WESTERN PLYMOUTH NEIGHBORHOOD ALLIANCE INFORMATION REQUEST

Applicants Xcel Energy and Great River Energy

Docket No.: PUC E-002/TL-11-152
OAH 8-2500-22806-2

Response To: Western Plymouth Neighborhood Alliance Information Request No. 5

**PROPOSED ROUTE
REBUILD AND NEW PORTIONS
Hollydale Project**

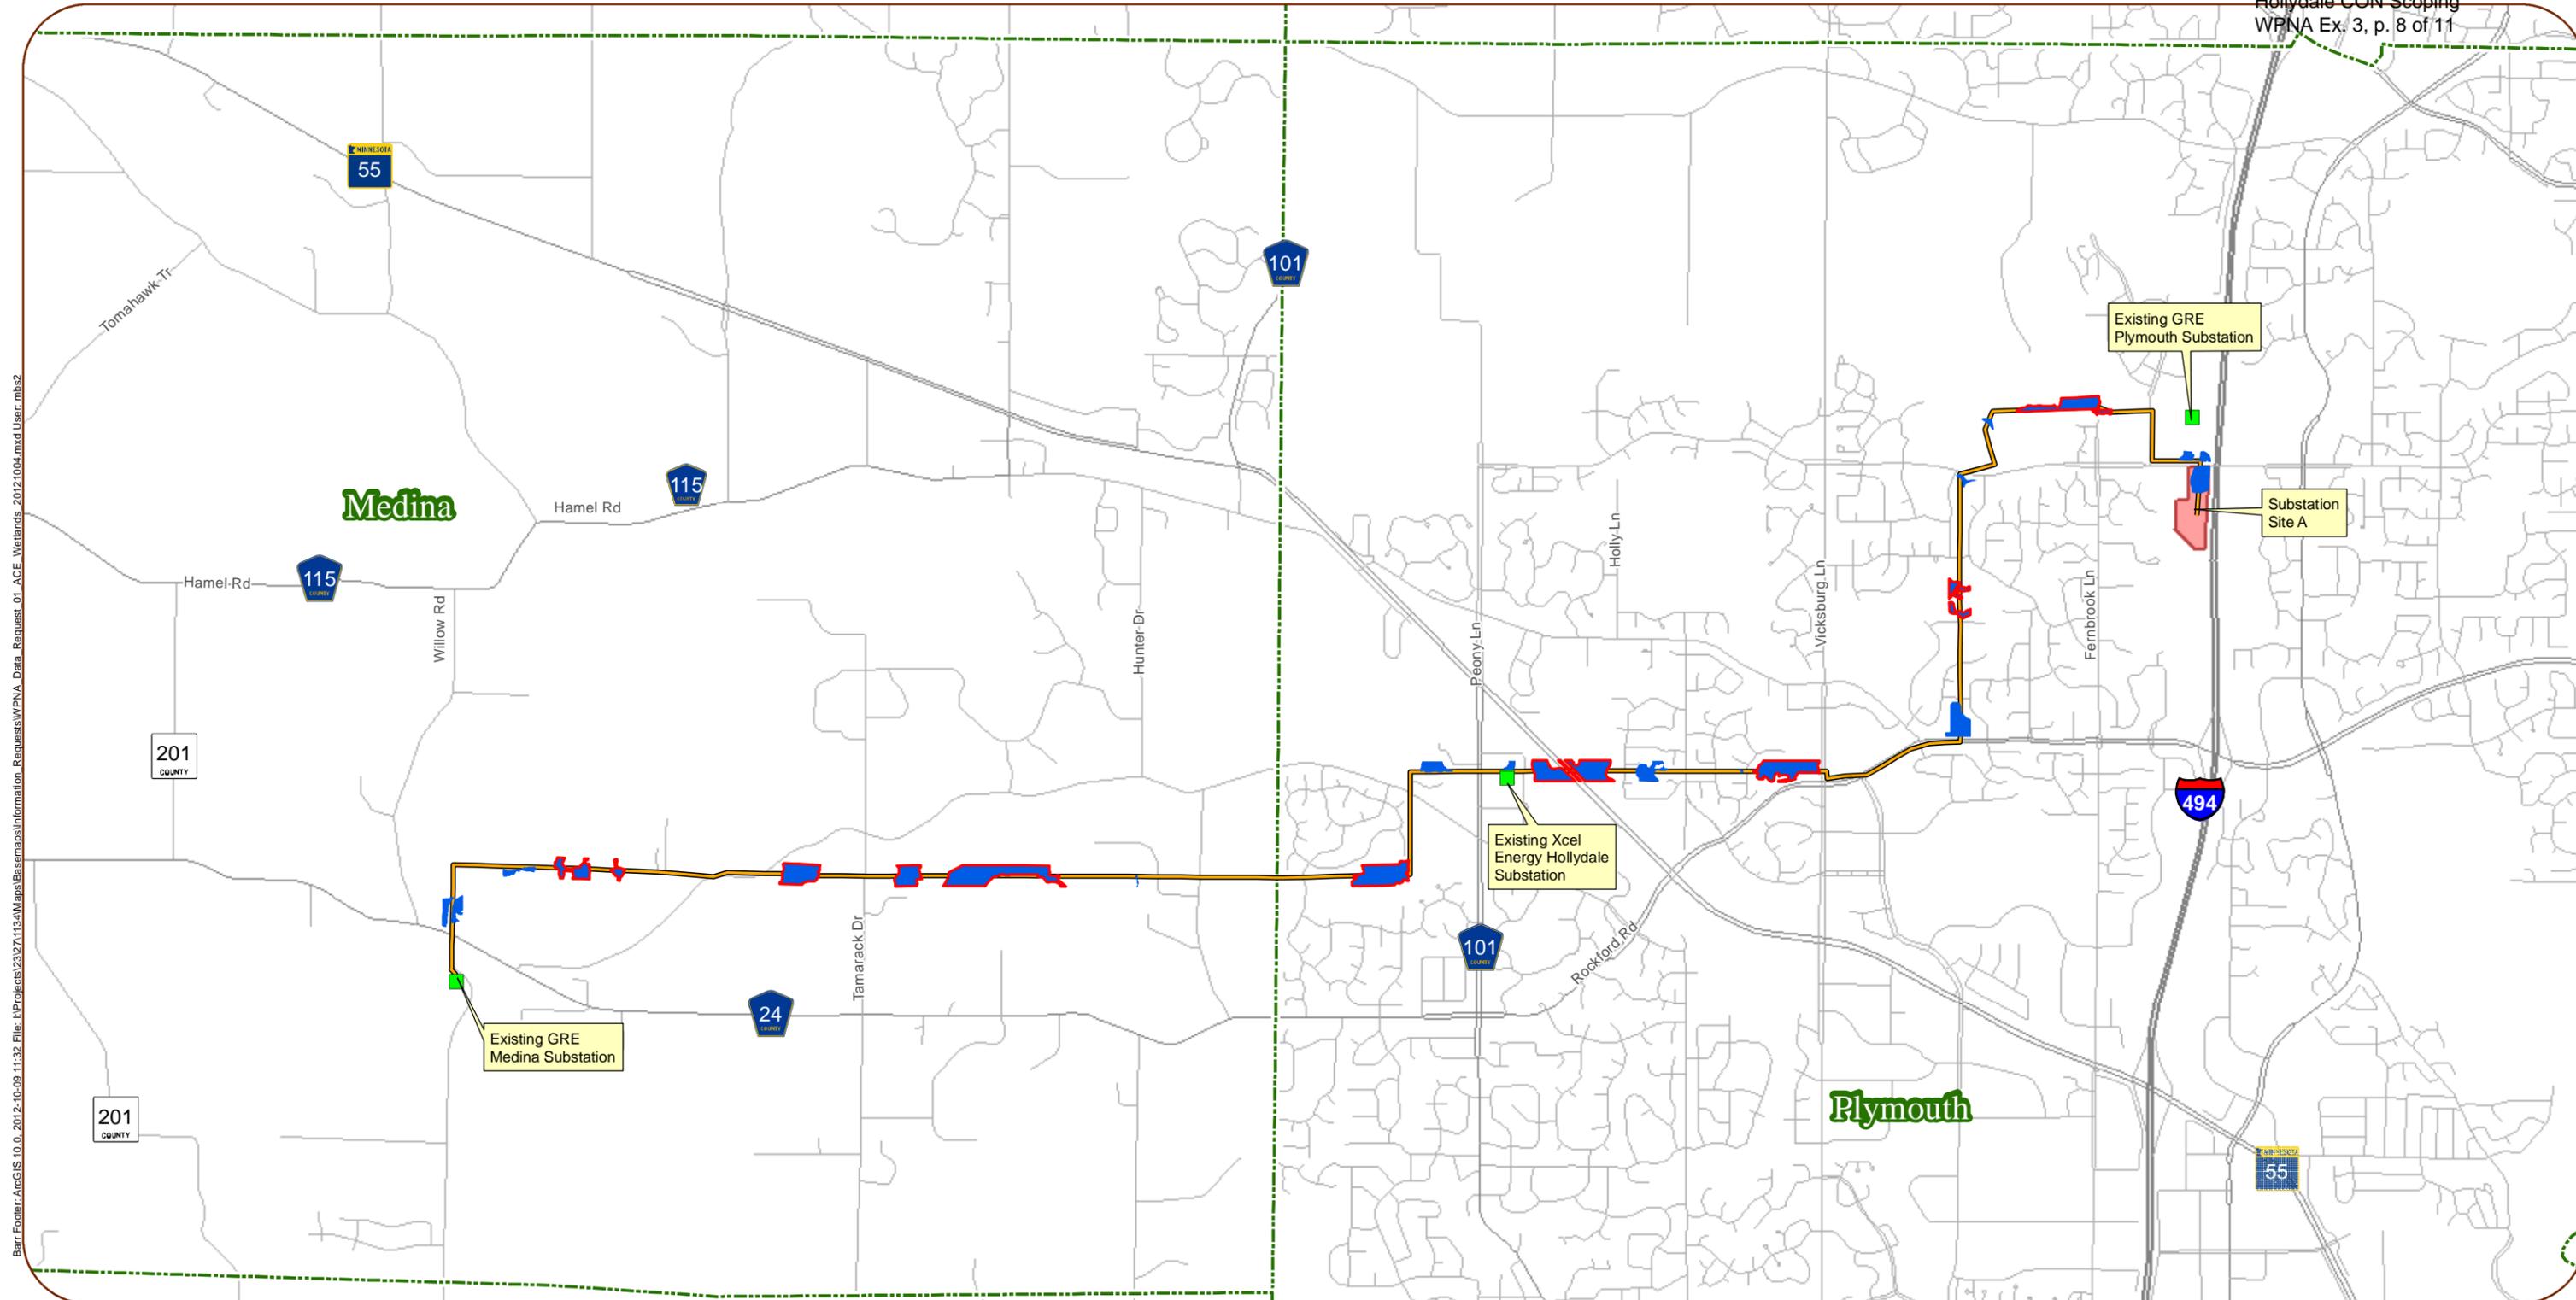
1. Define the section of the Proposed Route that is included in the “rebuild portion;”

- a. The rebuild portion of the route is the 8-mile section of the route that is currently occupied by the Great River Energy owned 69 kV transmission line BD. (See **Attachment 5-1**).

- a. The total lineal feet of the “rebuild portion” of the Project Route is 424,267 feet.

POTENTIAL ARMY CORPS
 OF ENGINEERS JURISDICTIONAL
 WETLAND LOCATIONS
 Hollydale Project

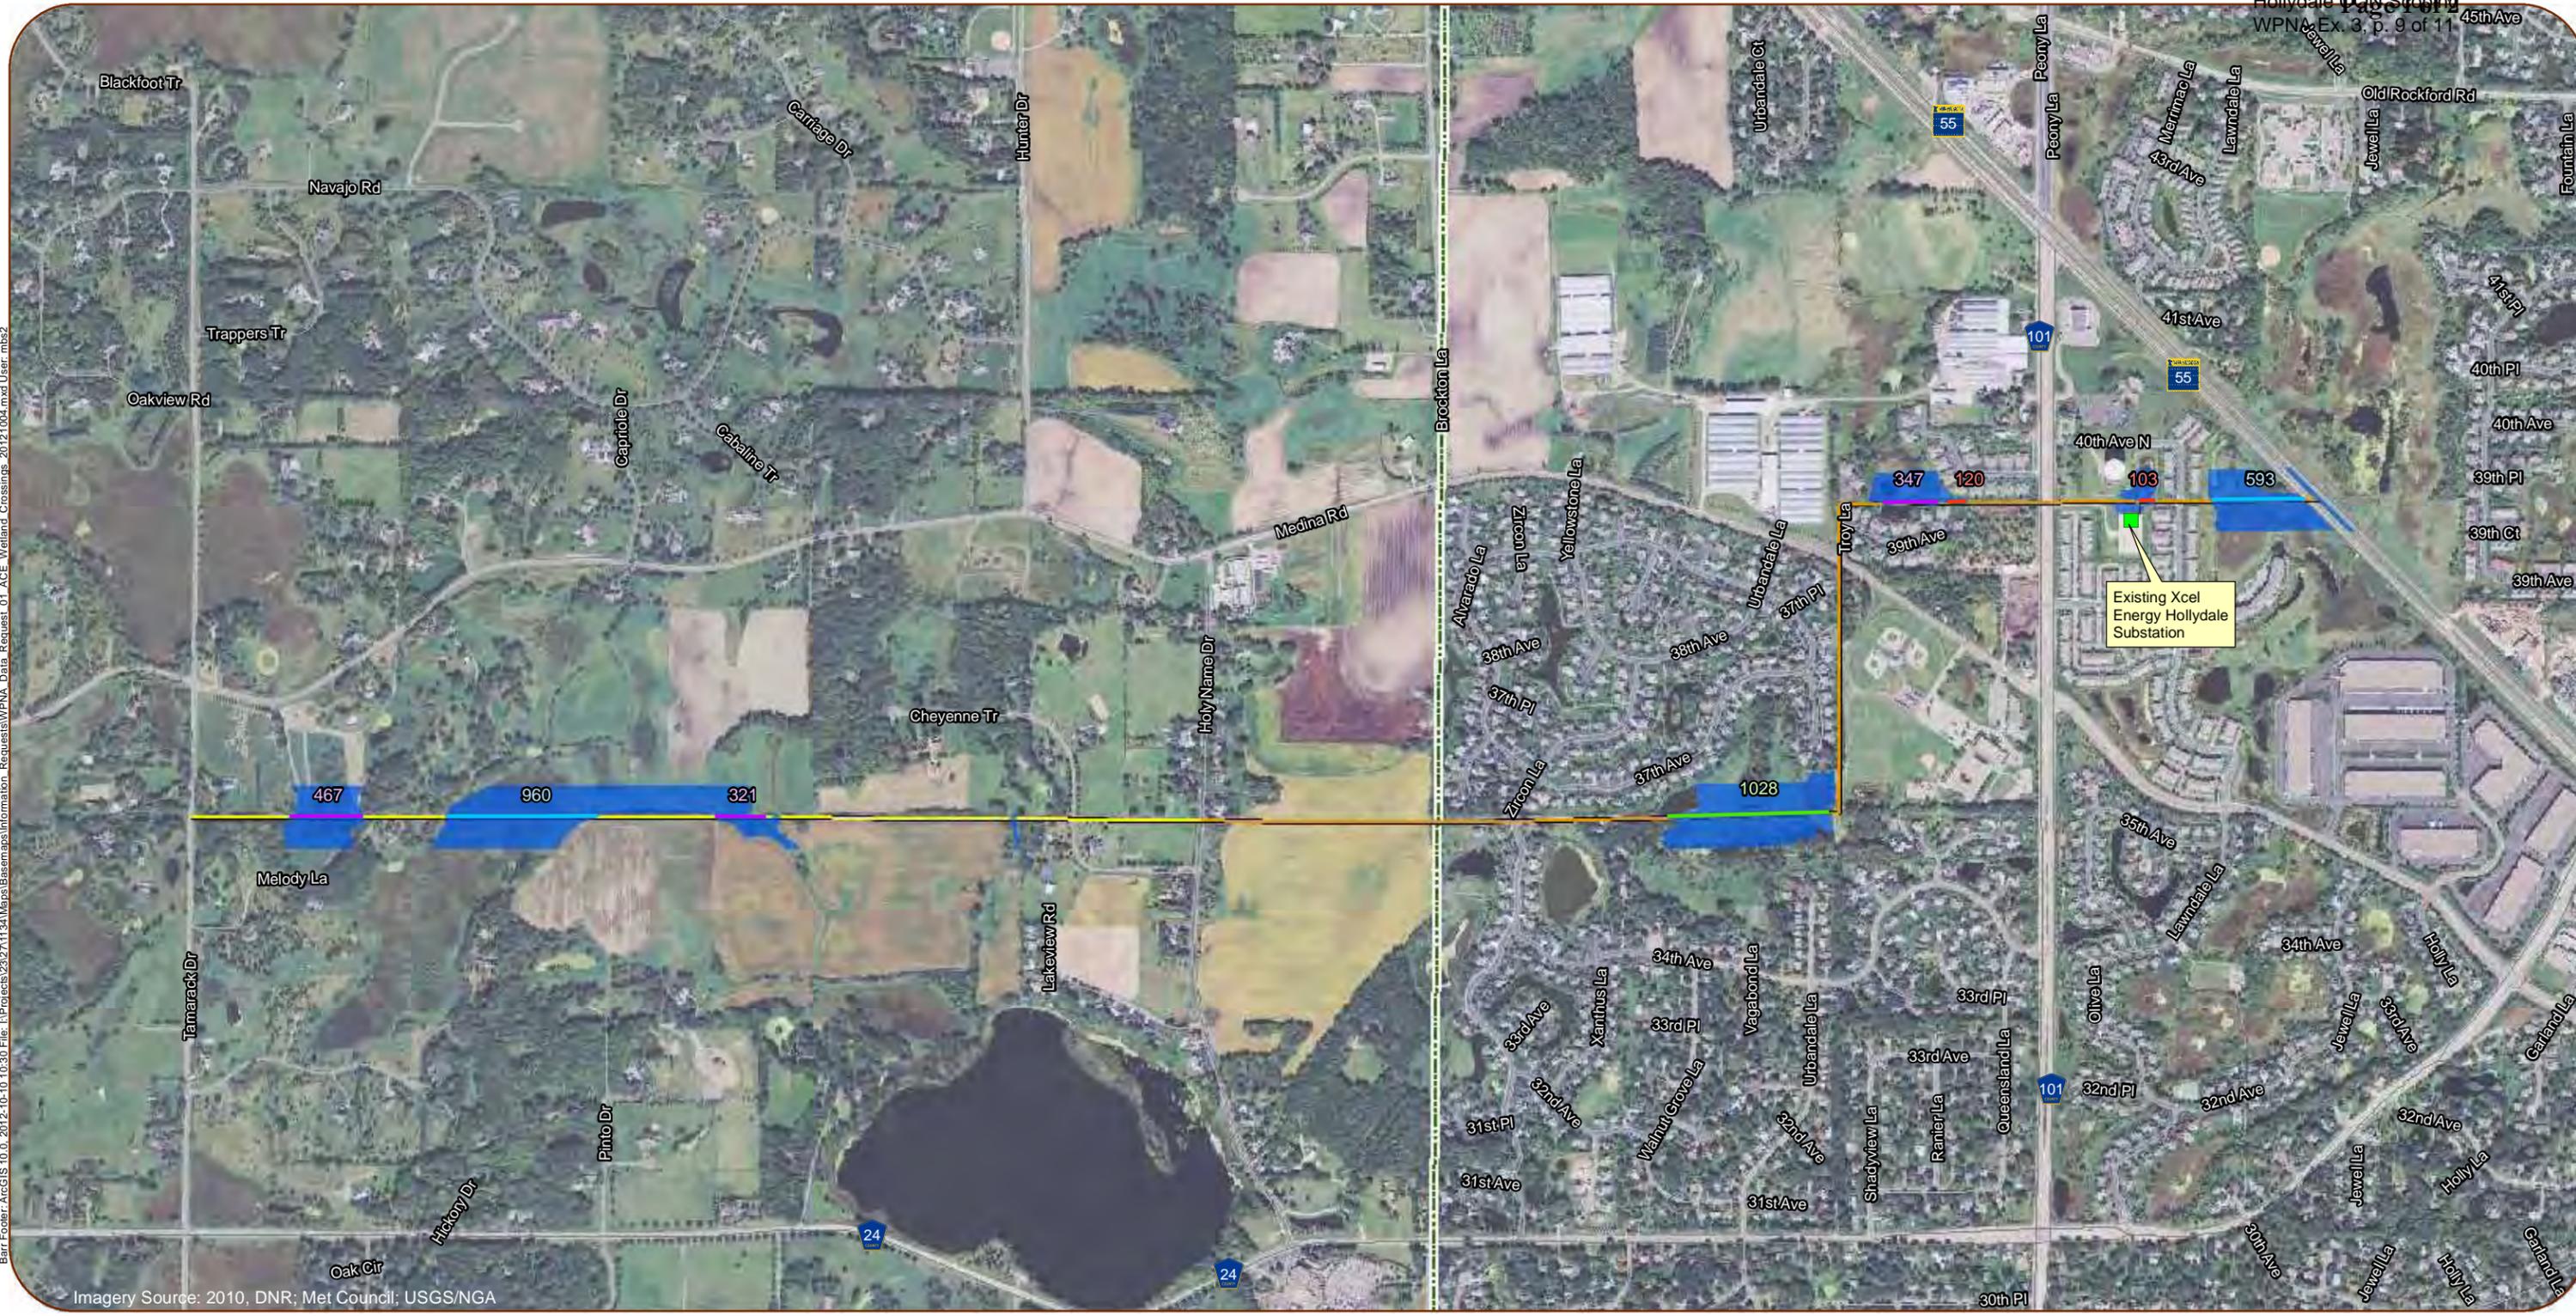
1. Identify on a map which 24 wetland crossings Applicants believe are potentially ACOE jurisdictional wetlands;

3. State Applicants' current understanding of whether the proposed wetlands crossings affect ACOE wetlands applying the criteria in subparagraph (2) above.

- a. See **Attachment 5-2**.

- a. ACOE jurisdictional wetlands are those wetlands that are adjacent to or have an interstate commerce connection. Regional ACOE offices determine if a wetland is within ACOE jurisdiction during a review process.

- a. Affects from the proposed wetland crossings will be in the same location and of equal areas as the existing conditions in ACOE- designated wetlands. See **Attachment 5-2**.

WETLAND CROSSING LENGTHS ALONG PORTIONS OF THE PROPOSED ROUTE
 Hollydale Project

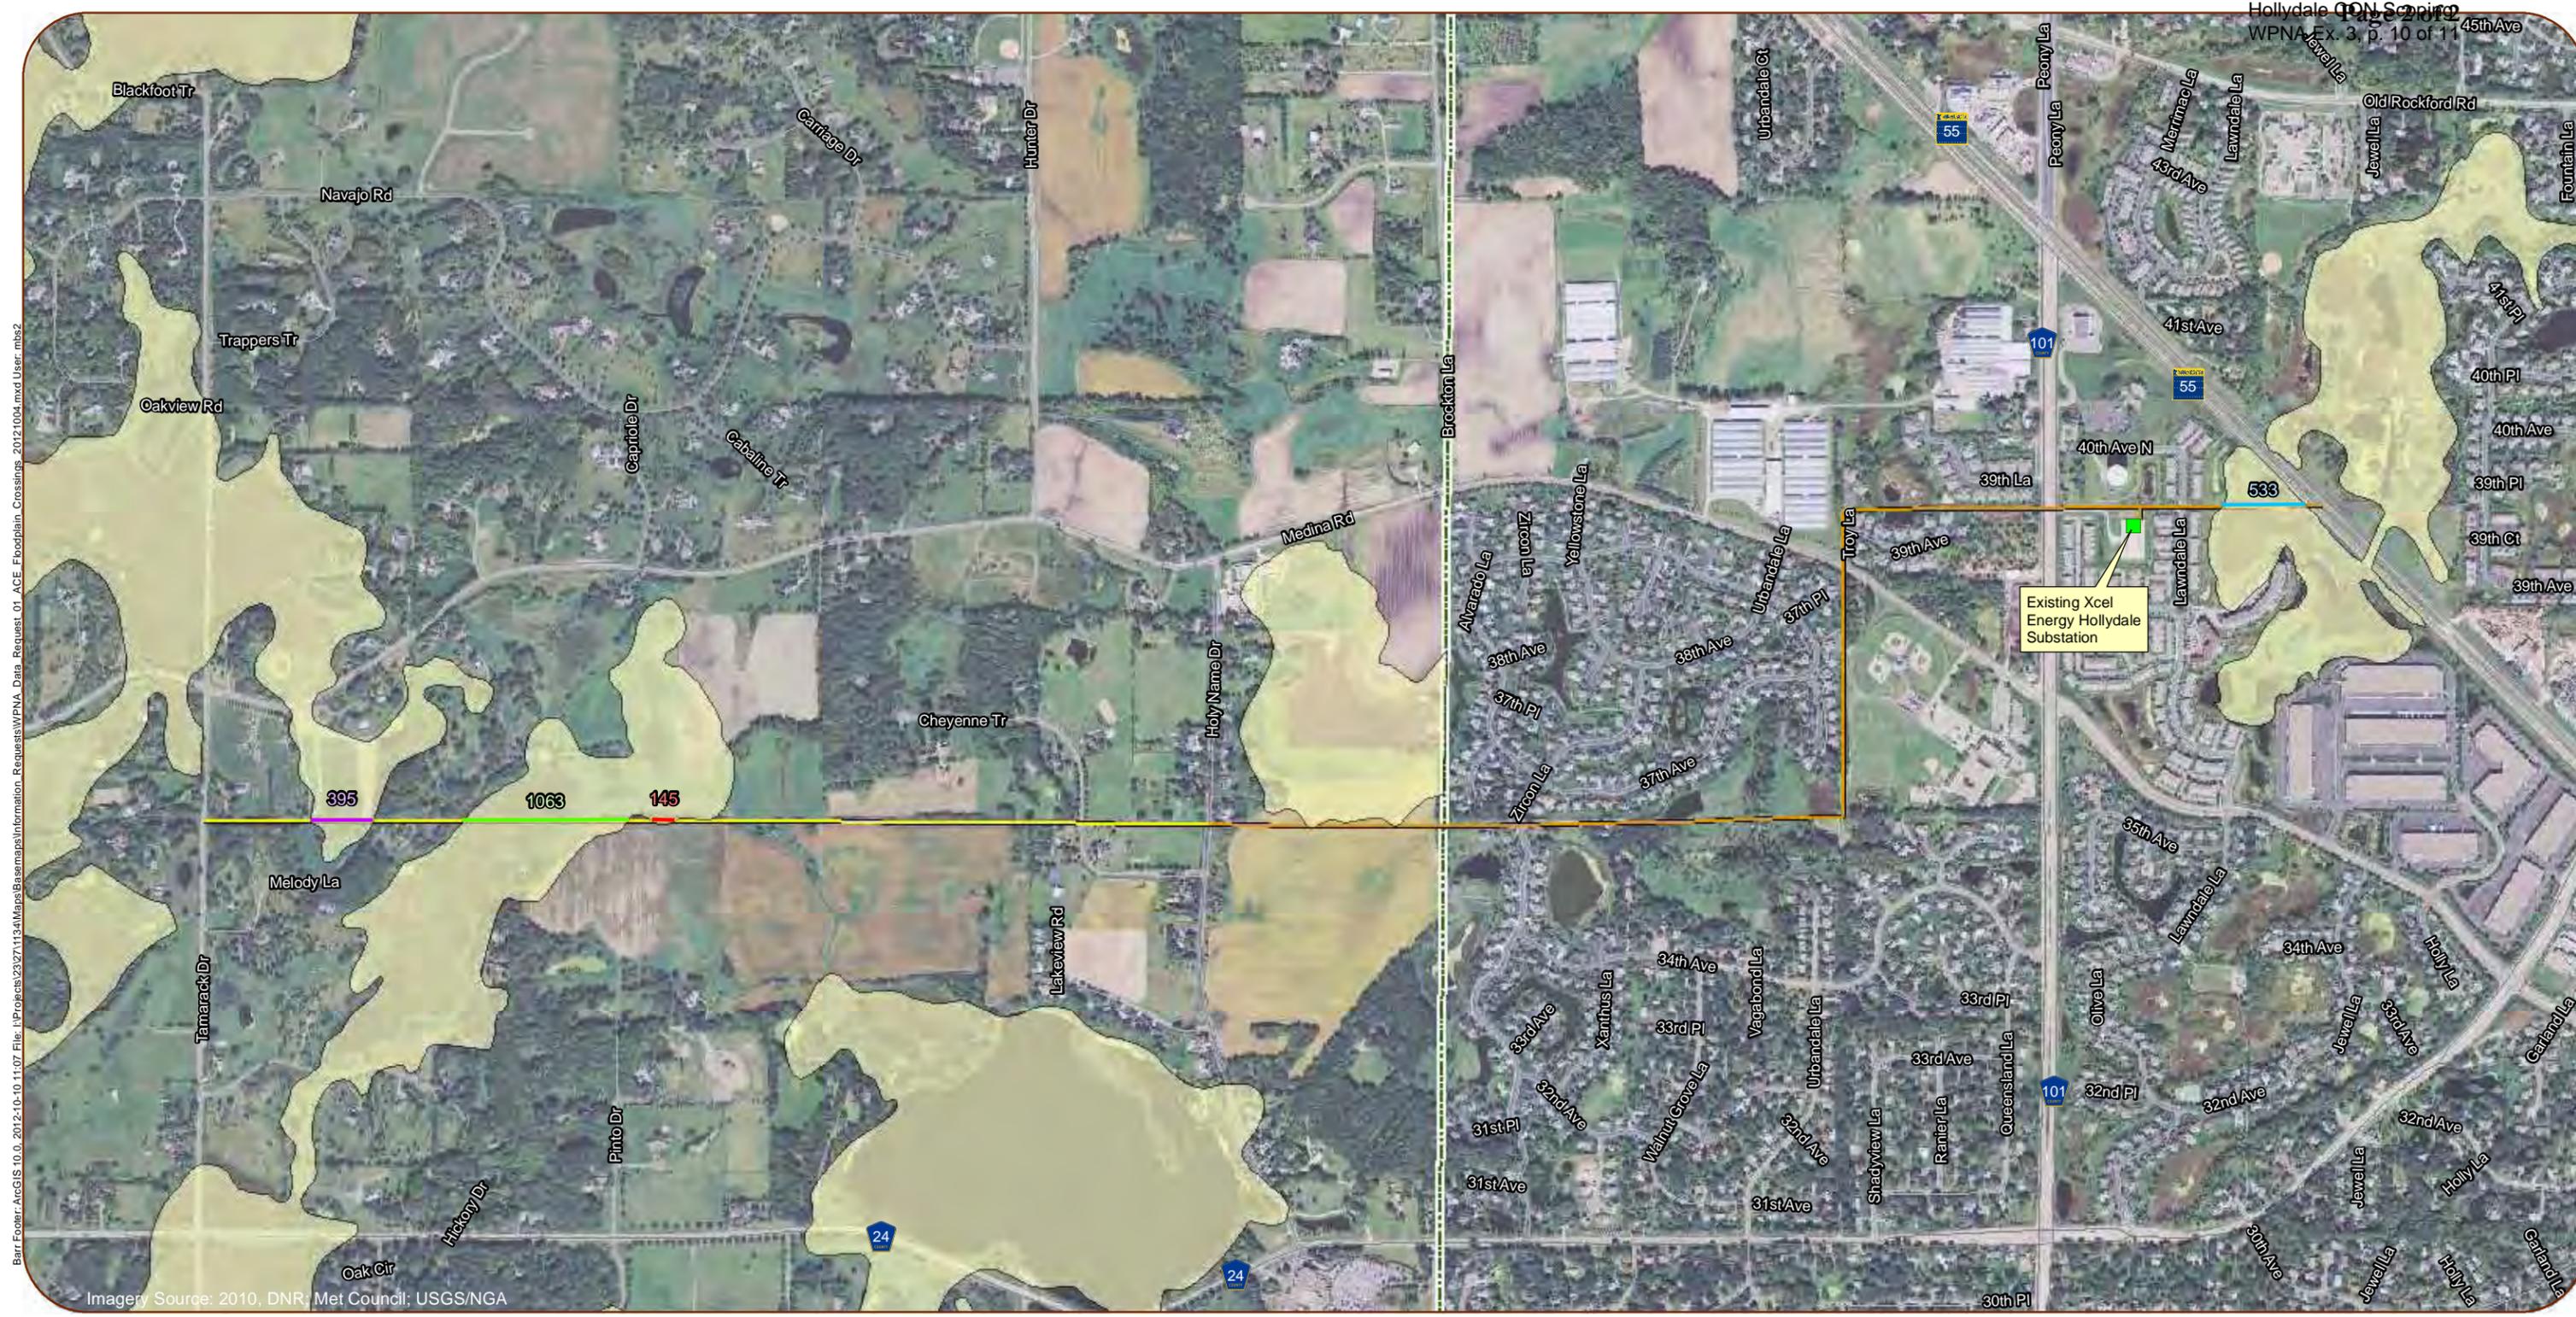
1. Describe in narrative or identify on a map with appropriate notations each wetland and floodplain within the Proposed Route right-of-way with a span to be crossed of a) from 100 to 300 feet; b) from 300 to 500 feet; c) from 500 to 1,000 feet; d) more than 1,000 feet.

a. See **Attachment 5-3**.
